Our Ref: 21637-20201106-GDARD Response

ADDENDUM 2 | RESPONSE TO GDARD'S COMMENTS DATED 26 OCTOBER 2020

Steyn City Properties (Pty) Ltd. plans to develop Riverside View Ext 84 on portions 124 and 185 of the farm Diepsloot 388 JR. The proposed zoning of the development will be *Special for: Place of Instructions, Residential buildings and Offices, including ancillary uses such as restaurants and shops* and aims to provide a school, offices and residential buildings. Private Open space will also be incorporated into the development which form parts of the Steyn City Parkland Residence which has been designed to be a modern, mixed land use and mixed income development.

Figure 8: Google Earth Imagery from May 2015

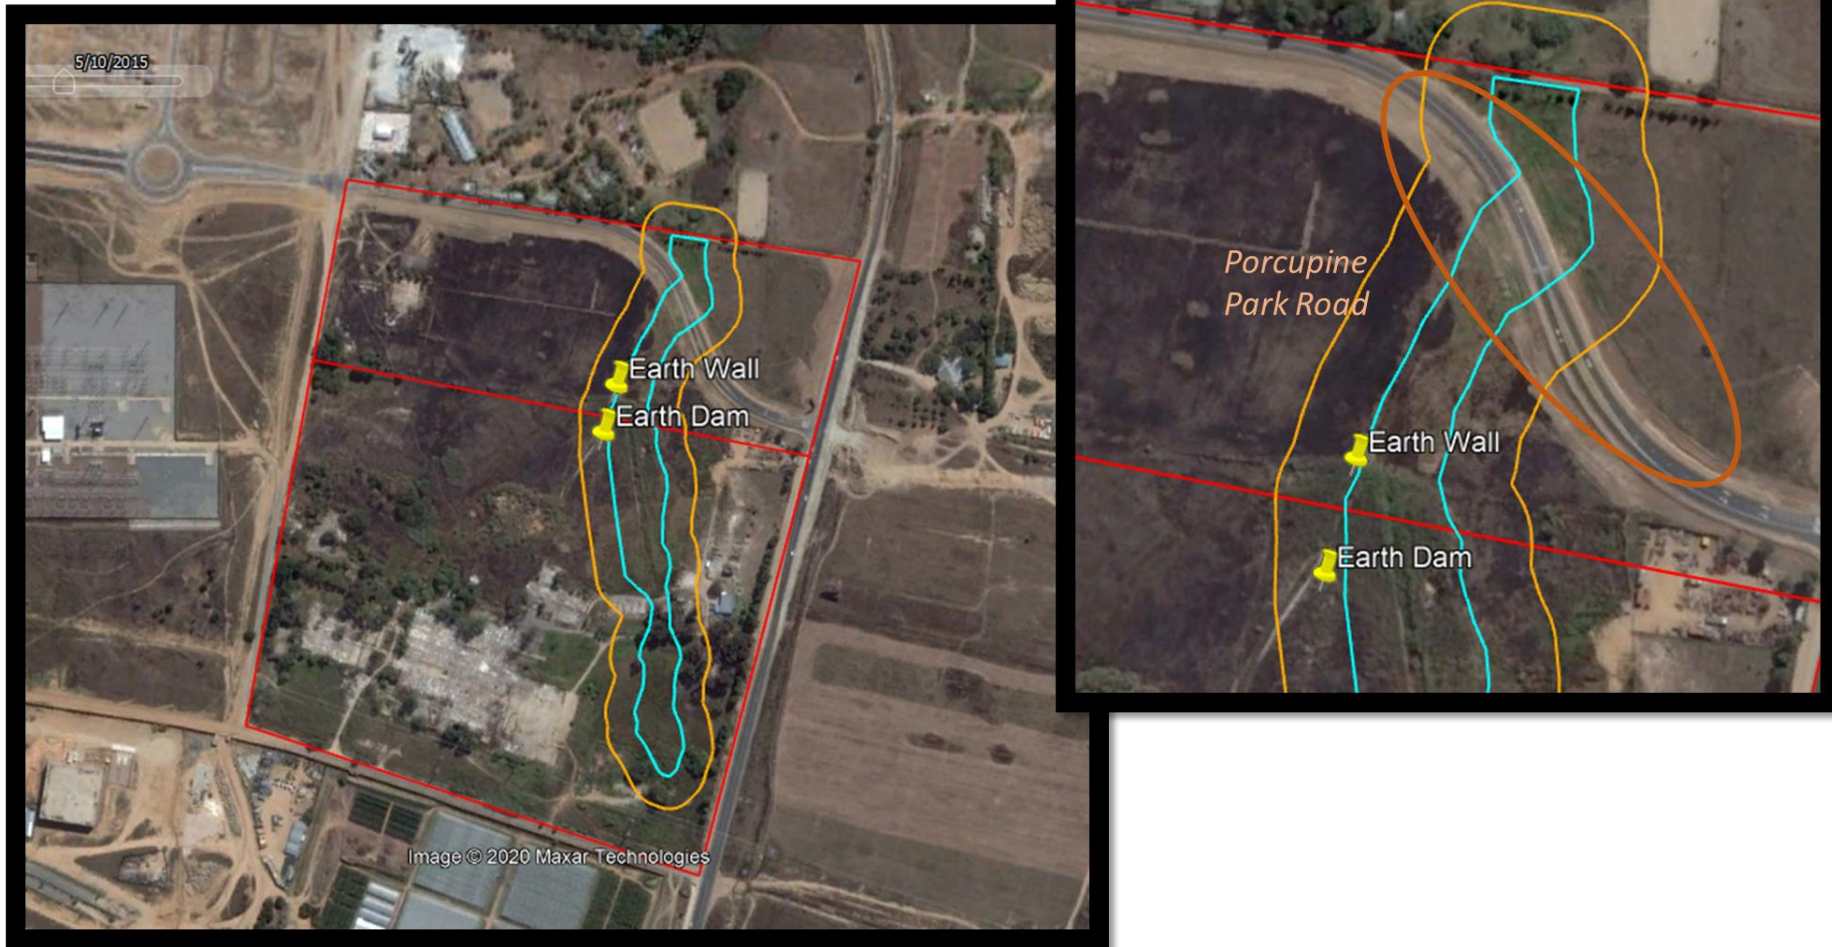
- Page 41 on wetland report indicated as figure 6.4 it display the wetland on site as per the Departmental Information System (GIS) but when its delineated on page 45 as figure 6.8 the other part which is on Erf 1 it's no longer delineated as wetland a clarity must be provided because even on site visit even the reeds were observed on that part.

Discussions with the Wetland Specialist have been undertaken and confirm that the wetland delineation was informed by a number of factors including desktop delineation, flow accumulation models, reference to existing GIS (such as the Department of Water and Sanitation (DWS) database and the National Wetland Map version 5 (NWM5) (Van Deventer et al, 2019)) as well as a detailed site assessment including auguring and a vegetation assessment. In addition to this, the specialist has been involved with the development for a number of years and therefore has a good understanding and experience with the previous development on site. Information from the Geotechnical Reports were also used to corroborate this understanding.

Google Earth imagery has therefore been utilized to provide a summary of the historic use of the site and how this has affected surface water. The aim of this is to provide a timeline and to explain the current status of the site.

From October 2011 to May 2015, a number of changes to the site took place. These occurred after the Geotechnical Reports and thus are not captured within. The exact details of the changes and why they took place is not available. However, evidence from Google Earth as well as the site visits, indicate that that formal drainage channels were put in place in the wetland.

Furthermore, whilst the school and old buildings on Portion 185 were demolished, the platforms they were built on remain in place and thus still channel stormwater and thus form the artificial source of water. This cannot be classified as a wetland and therefore was excluded from the delineation.

Figure 12: Stormwater Management System showing Multiple Releases

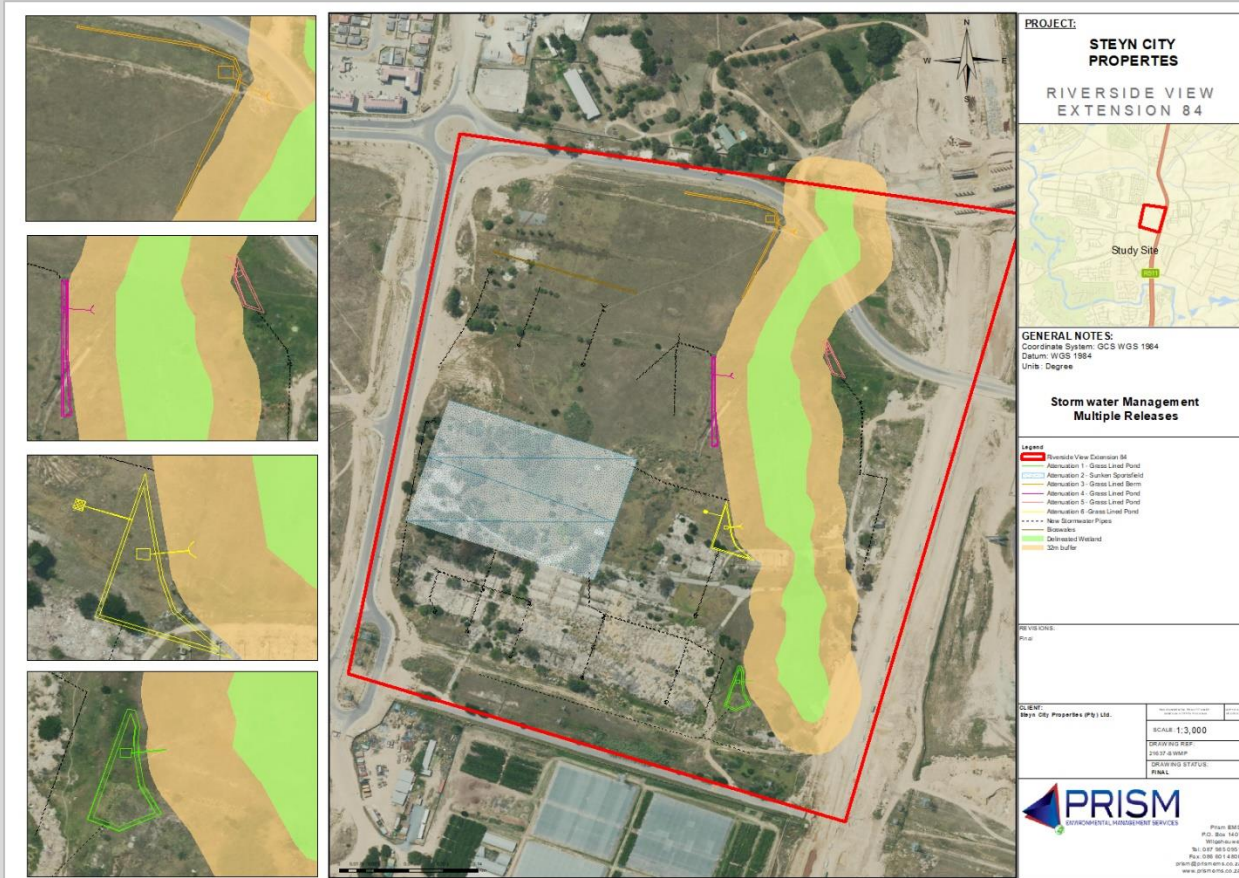
- *The stormwater management must be design in such a way that it will not dispense directly to the watercourse and its buffer zone and it must be submitted to the Johannesburg Roads Agency for consideration*

A stormwater management plan has been compiled by a professional engineer and provides for discharge overland within the wetland buffer. The plan utilized SUDS and all run-off from the site will be routed to the attenuation ponds of each respective catchment. Each catchment area drains into an attenuation pond whereby the run-off from the area is throttled to release into the wetland and buffer zone at the 1:5 year pre-developed flow. Energy dissipating structures will be constructed at each outlet to limit any erosion and encourage sheet flow into the wetland area.

Figure 12 provides an overview of this plan and highlights that there are 6 separate releases along the wetland buffer at separate locations which mimics the natural flows of the wetland and was recommended in consultation with the specialist.
